**From:** Scott, Keith L.  
**Sent:** Wednesday, April 14, 2010 2:10 PM  
**To:** Barkley, Erik J (317H)  
**Subject:** RIDs on CCSDS Green Book

Thank you for reviewing the SIS-DTN Green Book. I have a question about your item (a) and a bunch of proposed resolutions for your approval conditions that I'd like to talk with you about. Can you either call me at 703.983.6547 or propose some times when you'd be available to chat?

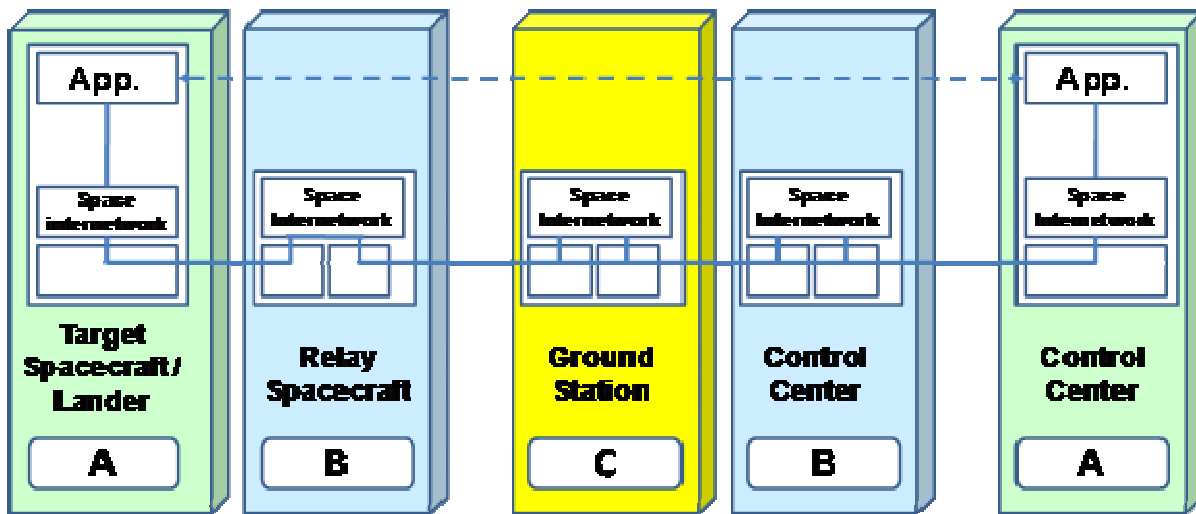
c) Figure 4-1 may need a little adjusting ? should the "B" Control Center be labeled "D" ? Otherwise unclear to me why the only Agency "B" entity is a Control Center...? If this is a "D" control center, then presumably in a DTN-aware network, Control Center 'A' can talk directly with ground Station 'C' ?

Hmmm. Yes, that would help. Or maybe 'D' should instead be 'B' to maintain label space compactness? Thanks!  
Proposed revised figure is:
